From: Peter Wilmott
Sent: 23 October 2018 18:02
To: Raymond Proctor
Cc: Martyn.white@arun.gov.uk
Subject: Bridge Club, Sudley Road, Bognor Regis -
Attachments: 20181023185532935.pdf

Project No./Ref: 300582/SK/1
 Project: THE BOONOR CHOPS
 Section: FRONT WALL - REMEDIAL WORKS
 Prepared: RW Checked: Date: 07/2018 Time:

From: Peter Wilmott
Sent: 10 January 2019 17:41
To: Martyn White
Cc: [REDACTED]
Subject: RE: The Bognor Club Wall - Application for Listed Building Consent.
Attachments: Bridge Club, Sudley Road, Bognor Regis - ; 20190110180630844.pdf; 20190110181002887.pdf

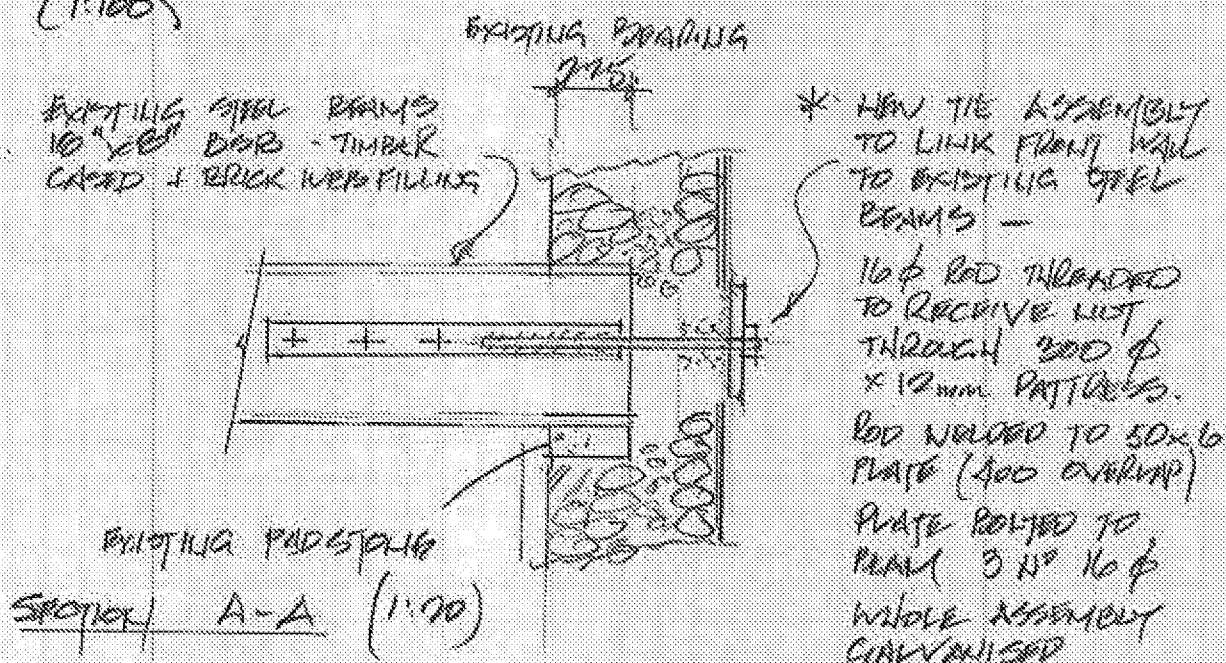
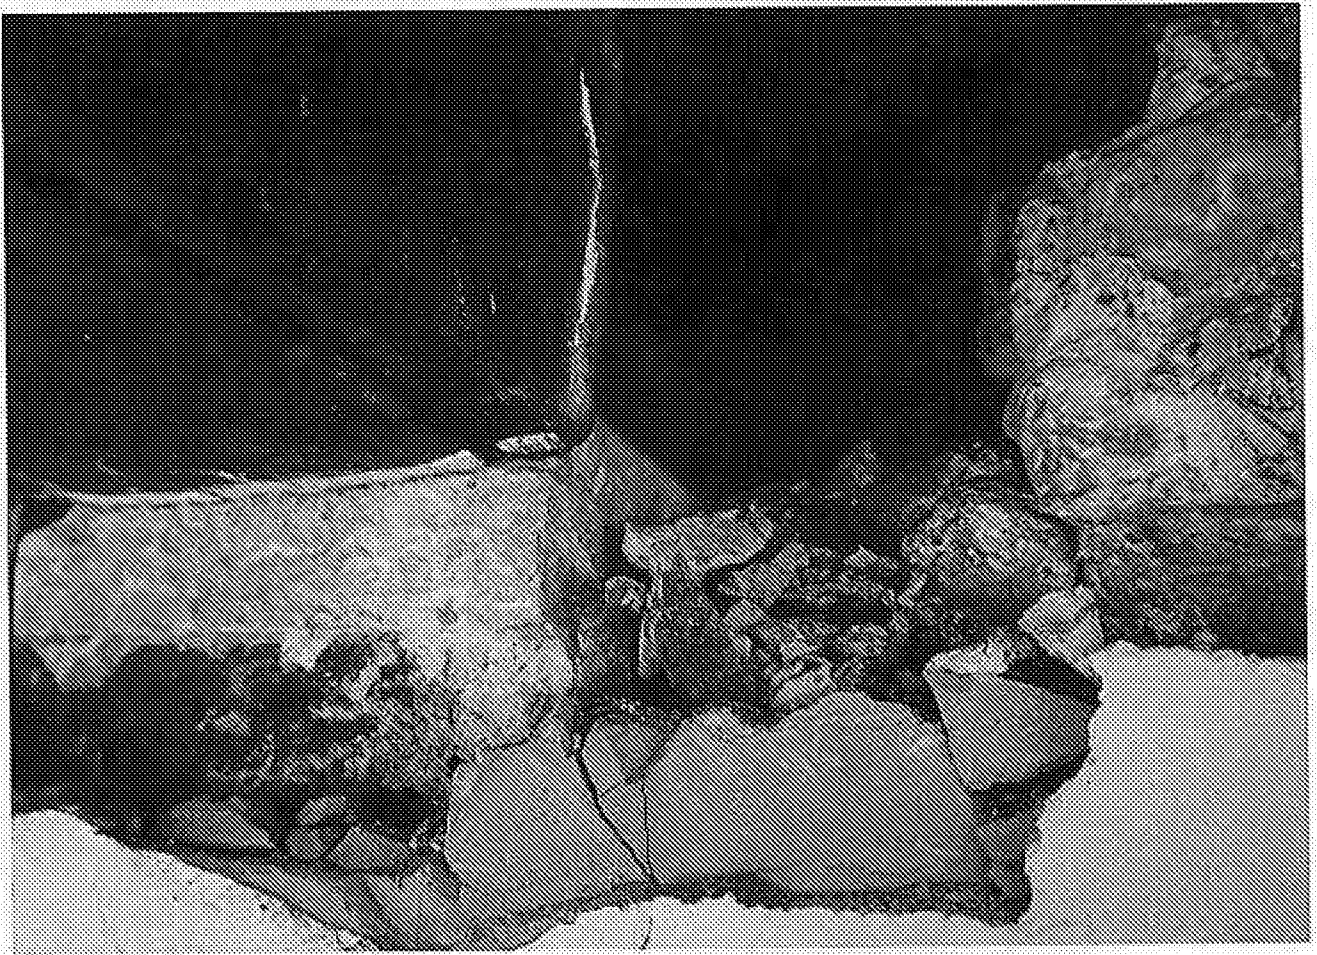
The opening up works on Saturday comprised an exposure of the north side of the north beam bearing. This enabled the full depth of beam bearing to be seen and also the inside surface of the outer "skin". As a result of my inspection I have established that the wall is entirely flint construction and is built with an inside "skin" 225mm thick, an outside "skin" of flint rendered to external face and a rubble core. The bowing movement of the external face of the wall is indeed skin separation with the outer "skin" moving away from the core having lost its initial

bond. The inner "skin" is restrained by the steel beams (not of the same age as the building) over the Billiards Room which bear on this part of the wall and is stable. The appearance of bearings is satisfactory and the beams are of robust section. All this is shown on the attached sketch 30058/sk/1 and photographs. The stability of the outer "skin" is not satisfactory and there is a likelihood that the outward movement will be progressive leading ultimately to a risk of collapse. The period of time for this to happen cannot be predicted with any certainty and as a result I am advising that the skin is anchored to the steel beams in the manner shown on my sketch. This will result in two pattress plates showing on the face of the wall a restraint detail commonly employed in such situations. By copy e-mail to Arun District Council I am asking if this proposal can be treated as an essential repair to be implemented as soon as possible. I am aware that ordinarily works to a Listed Building would be subject of Listed Building Consent but the process required to achieve this would take some time. The access tower erected by your builder has been left in place and given approval to progress the works in the near future this can be used for the installation process resulting also in cost savings for the club.

On completion of the two anchors the external skin will be stabilized. I would then advise that the CamTies or equal are installed on a grid to be agreed approximately 450mm centres vertically x 900mm centres horizontally. This installation would be to improve the overall anchorage of the front skin of the front wall and to achieve some core grouting. There would need to be some consultation with the tie manufacturer regarding installation in flint construction. If found impractical I would look at other options.
